DOCUMENT CHANGE REQUEST

DCR number 324 Changes required for: General
Date: 2007/02/21 Date sent: 2007/02/21
Status: IMPLEMENTED

Title: Transistors High Power NPN, based on type BUX77

Number: 5203/016 Issue: 1

Maximum Safe Operating Area Graph

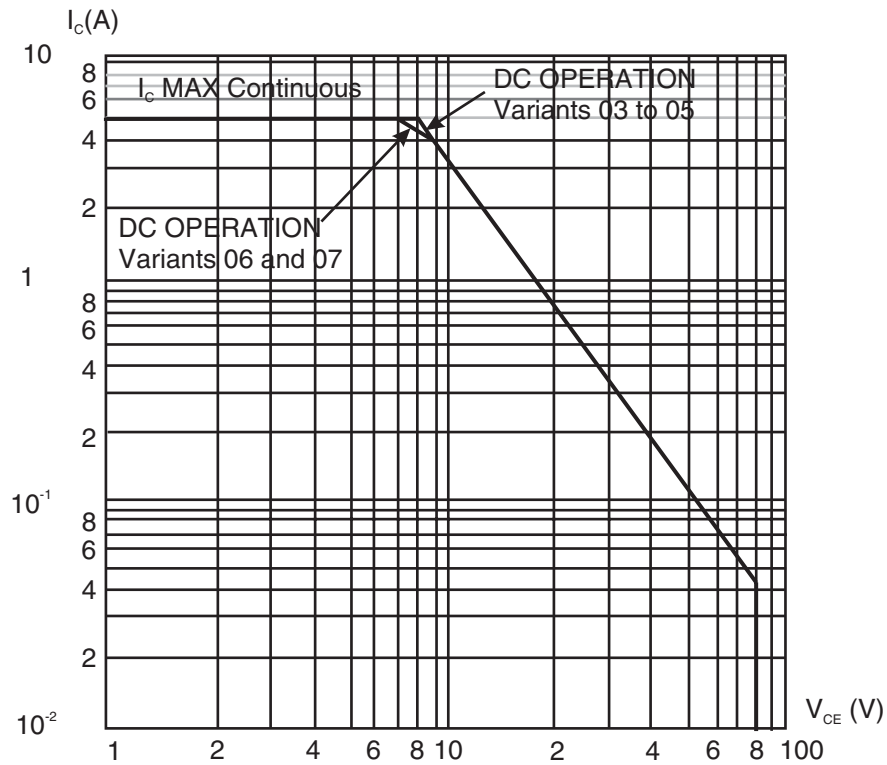
1. Rewording and restructure of various sections and paragraphs of the specification plus other editorial changes based on the layout and editorial content of other Detail Specifications already converted to ESCC format (e.g. changes described in DCR No. 203).
2. Deletion of any redundant paragraphs and information, e.g.: Mechanical Requirements.
3. Para. 1.7 High Temperature Test Precautions requirements moved to be a note in the Maximum Ratings table.
4. Deletion of obsolete lead finishes D2, D3 and D4 / Variants 01 and 02 from the available range (not supported by STMicroelectronics).
5. Figure 1(a) Parameter Derating Information moved to be a note in the Maximum Ratings table.
6. Figure 1(b) Forward Bias Safe Operating Area (Continuous DC) amended and moved to be a note in the Maximum

1.7.1 Metal Flange Mount Package (TO-66) - 2 lead

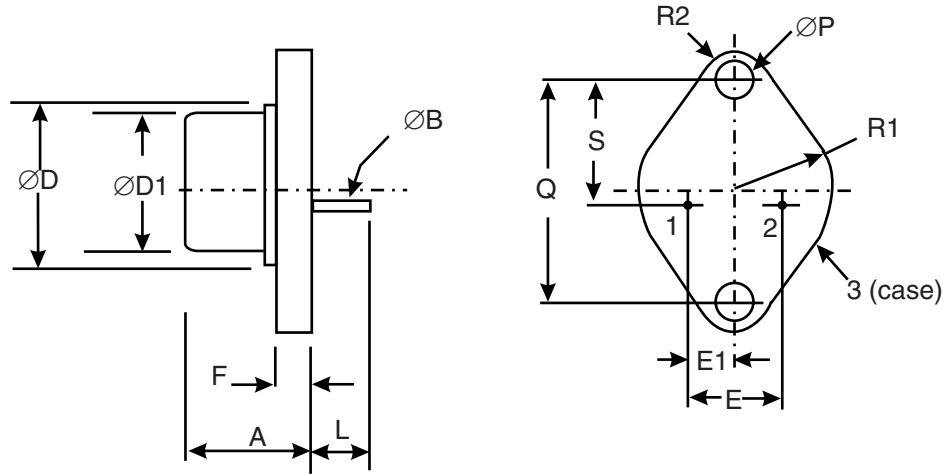
8. Figure 2 re-named â..Physical Dimensions and Terminal Identificationâ.; Figure 2(a) amended to reflect the TO-66 package currently supplied; Figure 2(b) amended to reflect the TO-257 package currently supplied. Consolidated notes added.

VOLTAGE WAVEFORMS

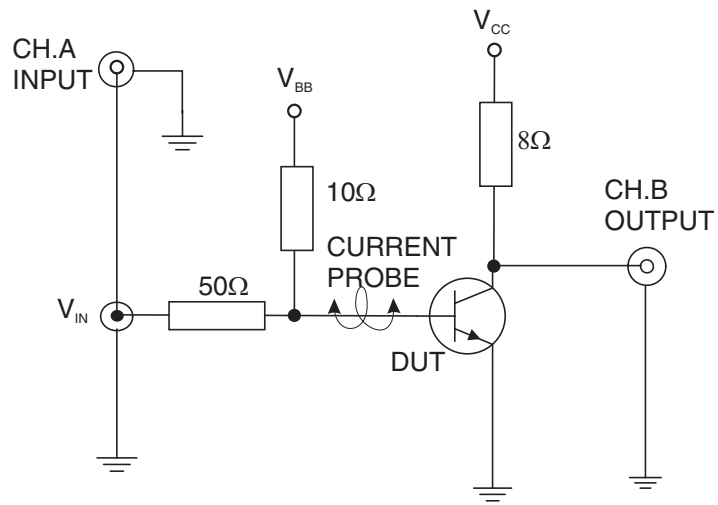
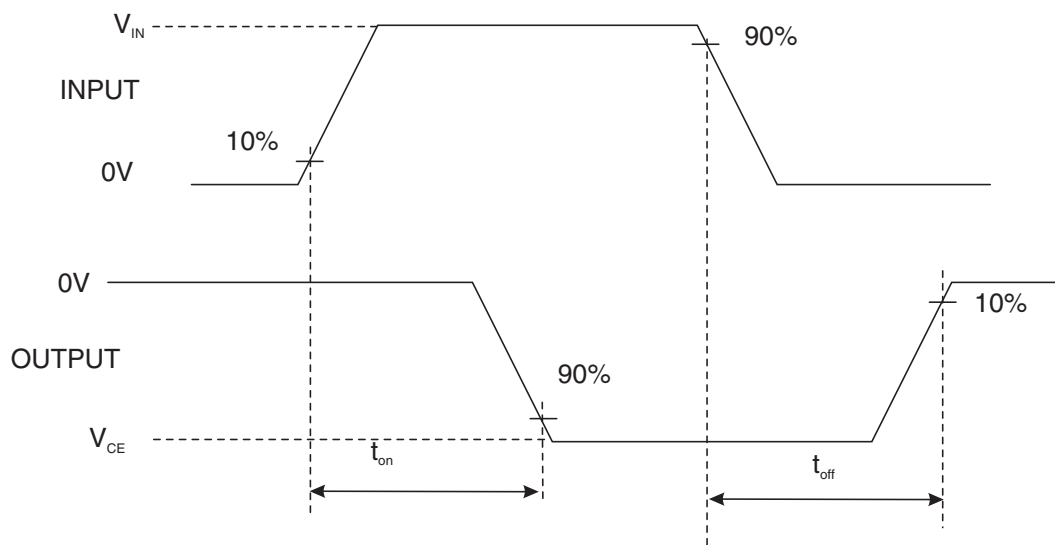
17. Table 2 and Figure 4: The Switching Times characteristics have been amended to reflect the new format.

Maximum Safe Operating Area Graph

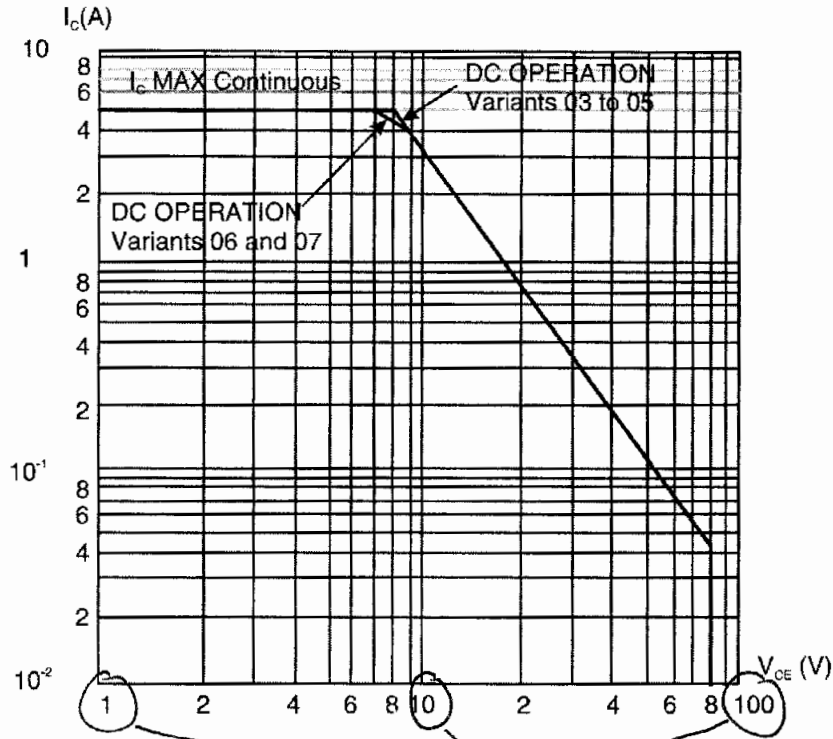
make lower &/or larger than the other numbers (eg: 6 8 100)
